Report Nos.: 50-269/87-08, 50-270/87-08, and 50-287/87-08

Facility Name: Oconee Nuclear Station

Enforcement Conference at the Region II Office: December 22, 1986

DUKE POWER COMPANY
OCONEE NUCLEAR STATION
ENFORCEMENT CONFERENCE
DECEMBER 22, 1986

FIGURE 2.

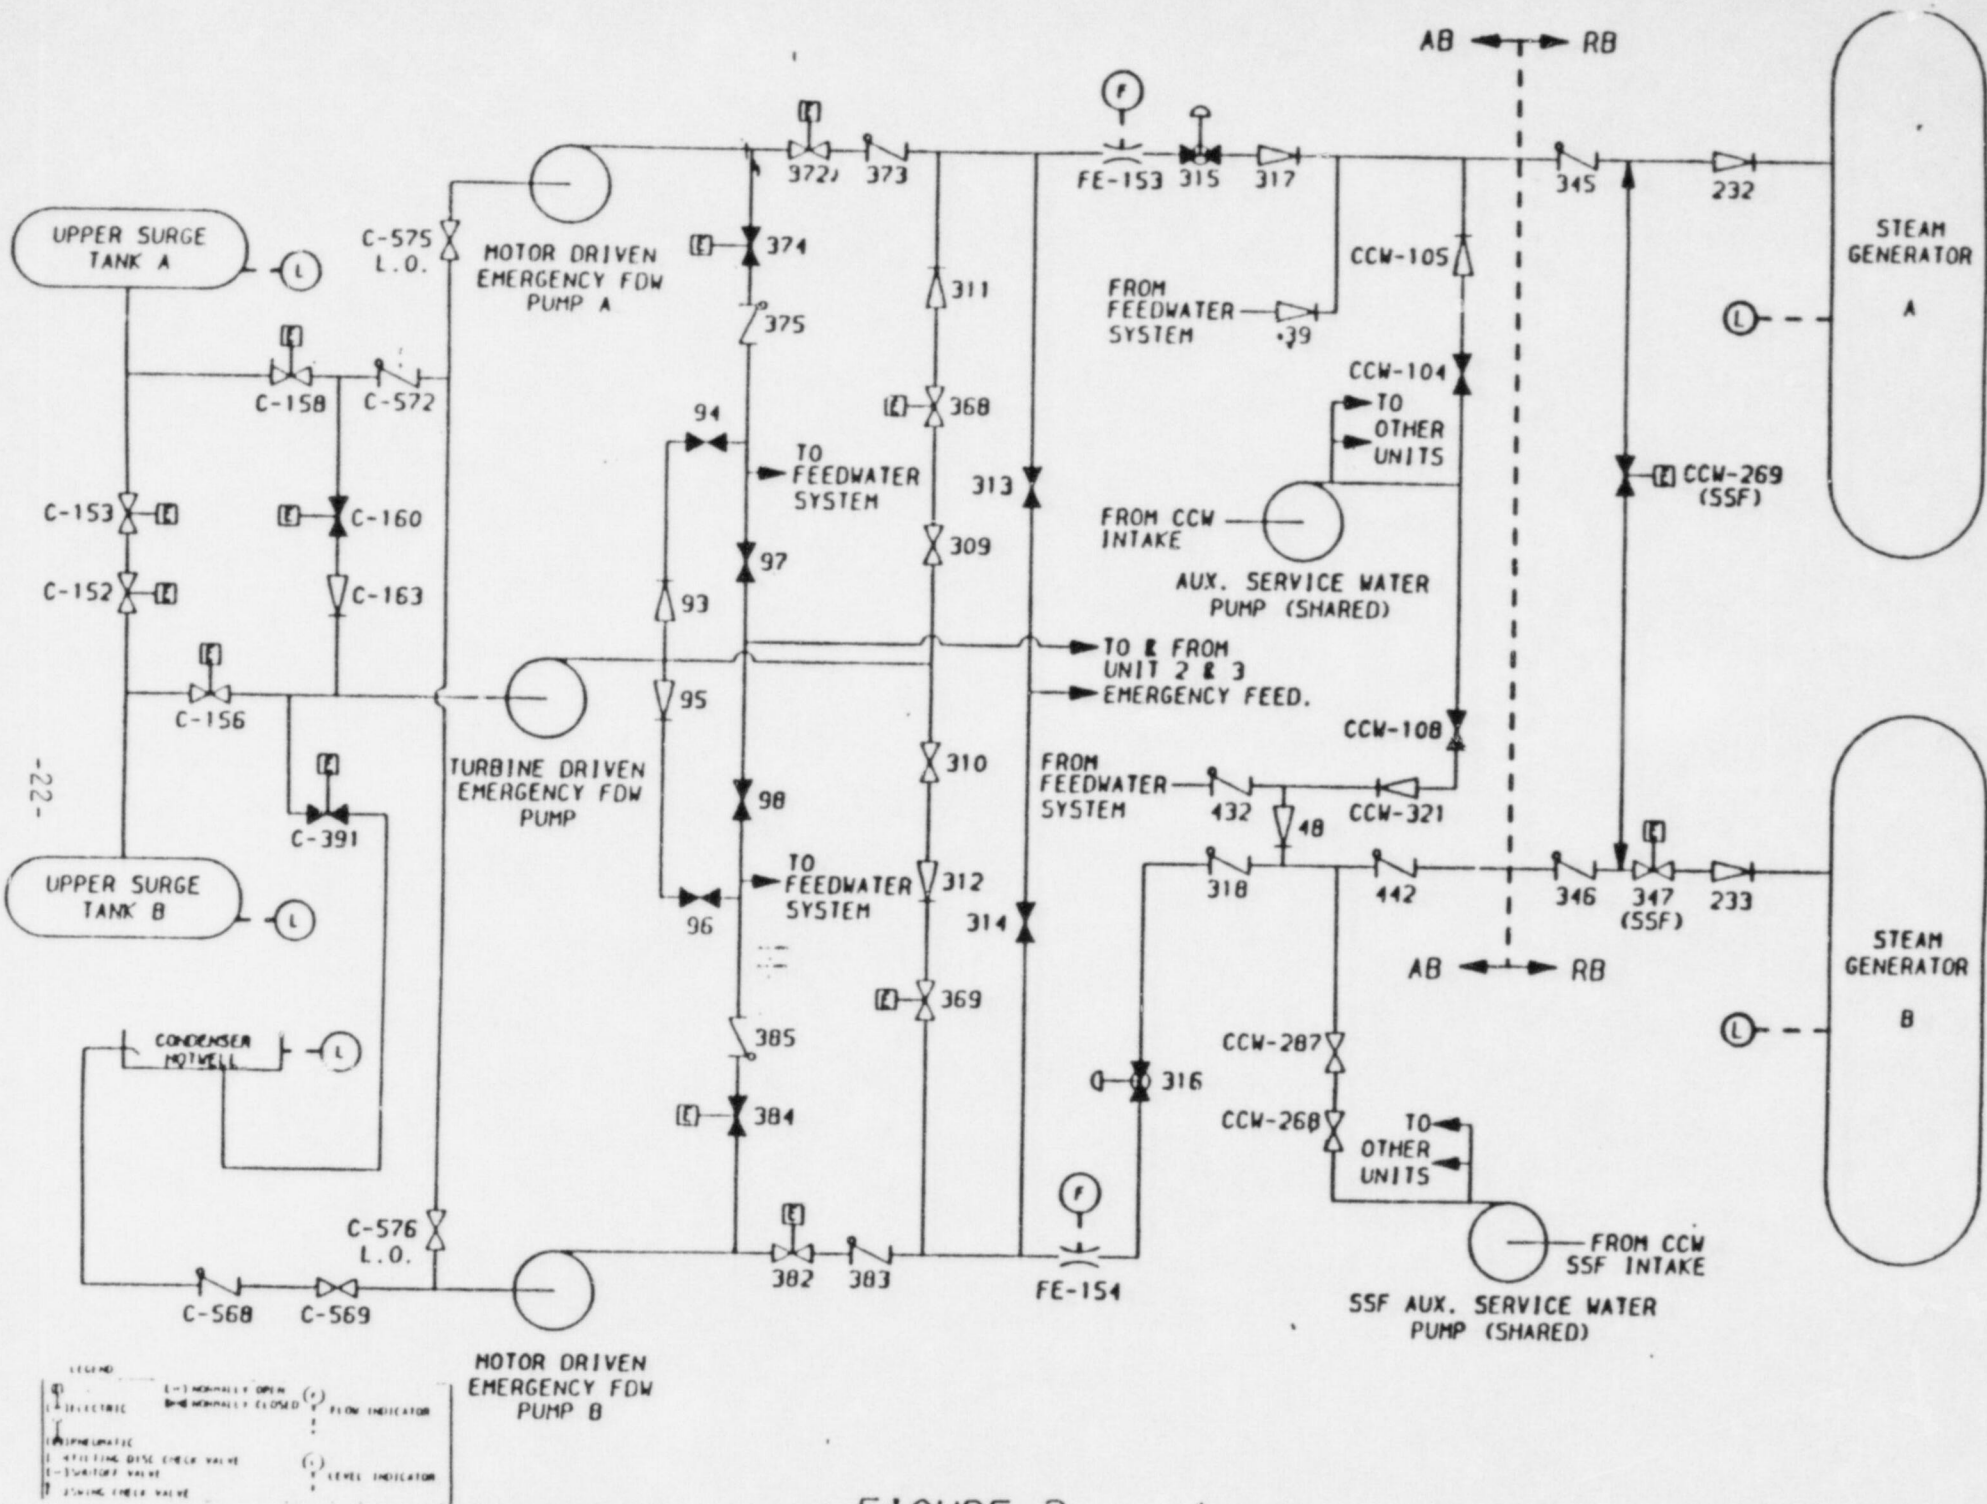
NRC CONCERN: FULL CYCLING AND FLOW VERIFICATION OF CHECK VALVES 2C-568 AND 3C-568 WERE NOT PERFORMED IN ACCORDANCE WITH THE PROVISIONS OF ASME CODE, SECTION XI, SUBSECTION IWV AS REQUIRED BY TECHNICAL SPECIFICATION 4.0.4. NO RELIEF FOR THESE VALVES WAS REQUESTED IN THE OCONEE NUCLEAR STATION INSERVICE INSPECTION PROGRAM.

- C-568 WAS NOT ORIGINAL EQUIPMENT
- WHEN ADDED IT WAS NOT CONSIDERED A PART OF THE IIP
- UNDESIRABLE FLOW PATH
 - . LOSS OF VACUUM
 - . SMALL VOLUME OF WATER AVAILABLE
 - . POTENTIAL PUMP DAMAGE
- PROCEDURAL GUIDANCE TO AVOID USING THIS PATH. PROCEDURE PREFERS TDEFWP FOR HOTWELL SUCTION.
- DUE TO THE HIGH PROBABILITY OF PUMP DAMAGE DUE TO LOSS OF SUCTION WHILE TESTING, A CONSCIOUS DECISION WAS MADE NOT TO PERFORM FLOW VERIFICATION ON C-568.

POST INSTALLATION TESTING

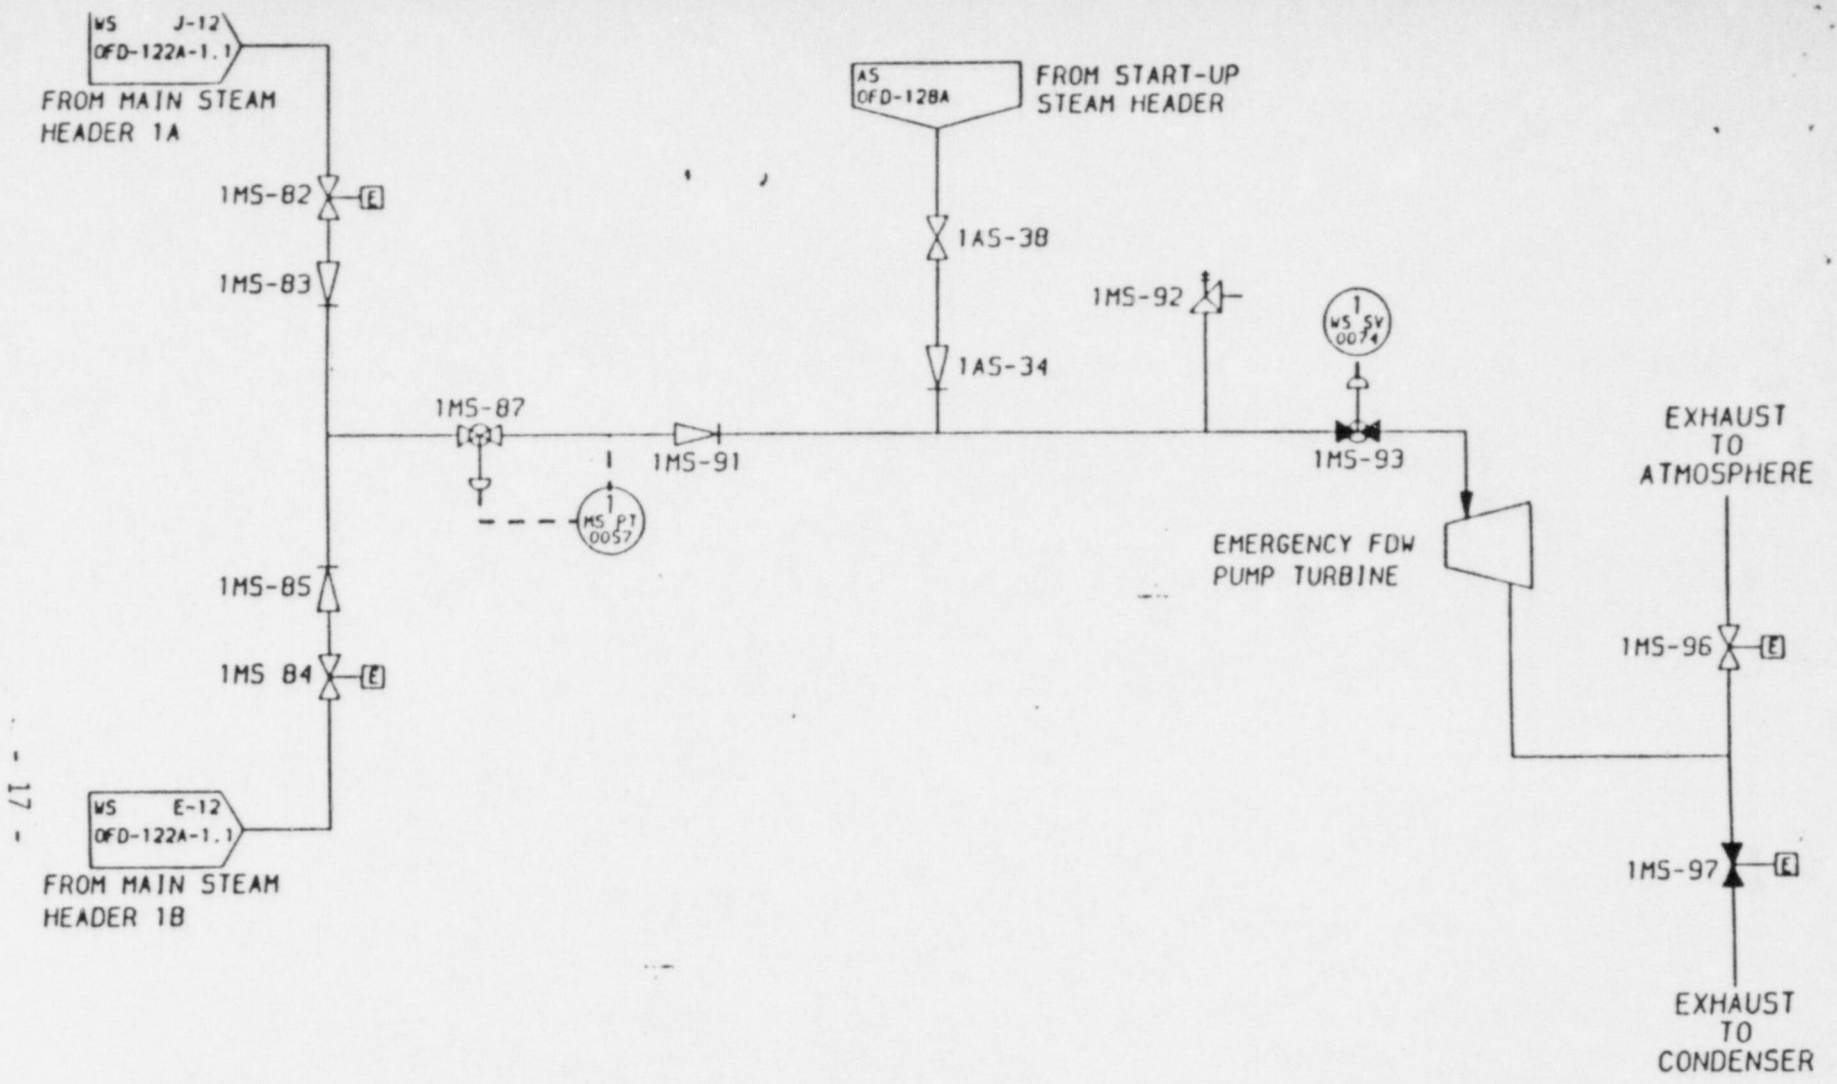
- MODIFICATION TO THE MDEFW PUMP SUCTION FROM THE HOTWELL
 - . #1, MARCH 1986
 - . #2, SEPTEMBER 1986
 - . #3, OCTOBER 1986
- C-568 WAS TESTED FOLLOWING MODIFICATIONS
 - . #1, APRIL 9
 - . #2, OCTOBER 12
 - . #3, OCTOBER 15

- C-568 ADDED TO IIP FOLLOWING TESTING AS REQUIRED BY THE INSERVICE INSPECTION PROGRAM WITHIN 60 DAYS OF THE END OF THE REFUELING OUTAGE

- AT THE TIME OF SSFI, UNIT 1 C-568 HAD BEEN TESTED AND ADDED TO IIP
- PLANS WERE IN PLACE TO ADD 2C-568 AND 3C-568 TO IIP WHEN MODIFICATION WAS COMPLETE
- OCONEE HAS BEEN IN COMPLIANCE WITH THE PROVISIONS OF IWV FOR VALVES C-568

FIGURE 1.
STEAM SUPPLY FOR TURBINE DRIVEN EFW PUMP (UNIT 1.)

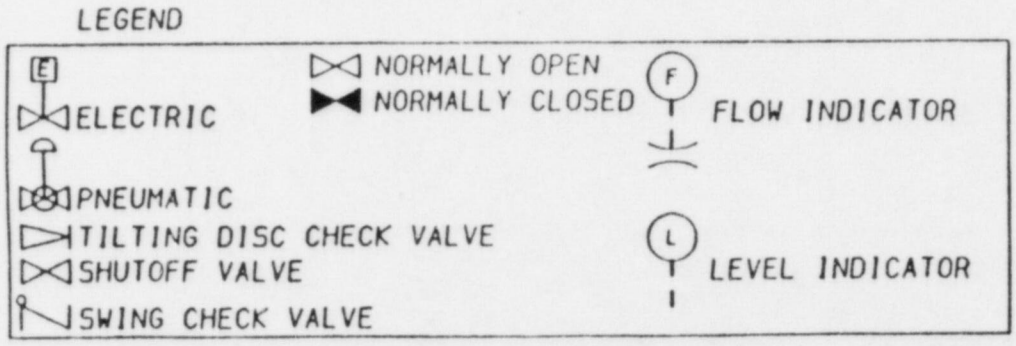
NRC CONCERN: MS-83 AND MS-85 ARE NOT PERIODICALLY TESTED IN THE REVERSE FLOW DIRECTION. LOW STEAM FLOWS HAVE BEEN KNOWN TO CAUSE DEGRADATION OF CHECK VALVES IN SIMILAR APPLICATIONS (IEN 86-09).

- PROVISIONS FOR REVERSE FLOW TESTING WERE NOT PROVIDED IN ORIGINAL DESIGN.
- IE INFORMATION NOTICE 86-09 WAS REVIEWED BY DESIGN ENGINEERING AND FOUND NOT TO BE A SIGNIFICANT CONCERN AT OCONEE.
- MS-83 AND MS-85 ARE TESTED (FORWARD FLOW) IN ACCORDANCE WITH THE INSERVICE INSPECTION PROGRAM.
- COST OF MODIFICATION REQUIRED FOR REVERSE FLOW TESTING IS NOT WARRANTED COMPARED TO BENEFITS GAINED BY THE ABILITY TO TEST FOR BACK FLOW.
